MECKLENBURG COUNTY
DEPARTMENT OF ENVIRONMENTAL HEALTH

MECKLENBURG COUNTY ENVIRONMENTAL HEALTH
SITE EVALUATION REPORT
SERIAL NUMBER 10049

Subject: Property located at 8116 Winterwood Place
File: 3300A

MEMO: File 20136

Sketch For Memo to File 20136
W. R. Marlin - Soil Scientist 5-29-86

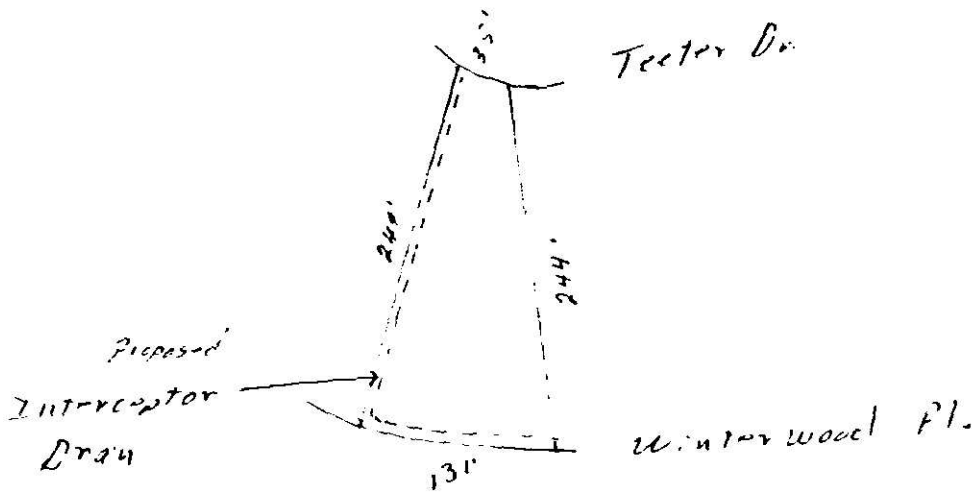
The front portion of the lot (from the street to approximately 75-100 feet into the lot) is the widest portion of the tract. The soils in this area are provisionally suitable with respect to structure (blocky), texture (clay), depth (greater than thirty-six inches to ground water and saprolite), and slope (2-8%). The lot would require a 100% repair area. However, the lot is classified as unsuitable with respect to available space. it appears that there may not be enough area to install the system and the repair area if needed.

In the event that the lot is determined to have an adequate acceptable soils area for the system installation, it is recommended that an interceptor drain be installed along the left property line as viewed from the street. This drain should extend to the rear of the lot and cross over the front of the lot to an outlet on the right side of the lot. Depth of the interceptor drain should be approximately four feet. A narrow trench (approximately 8 inches wide) with a drain in the bottom and backfilled with clean gravel should be sufficient.
